Access Compliance Report Public Rights-of-Way (Curb Ramps)

Main Street: STRAWFLOWER_ST Cross Street: ABELIA_ST Location: SE

ADA ID: RPAT211102140126 Ramp Type: Type 4 - Parallel Initial Pass/Fail: Pass Overall Compliance: No Severity Score: 10

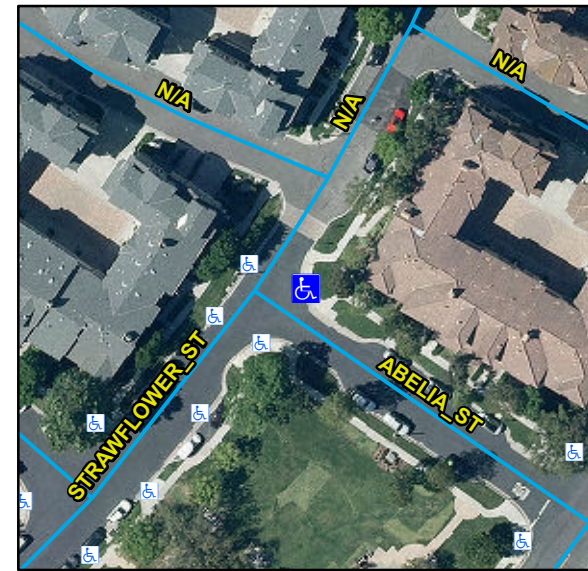
R204.3, R305, STD 1115

Remove & Replace Curb Ramp With Two New Directional Ramps or Equivalent.
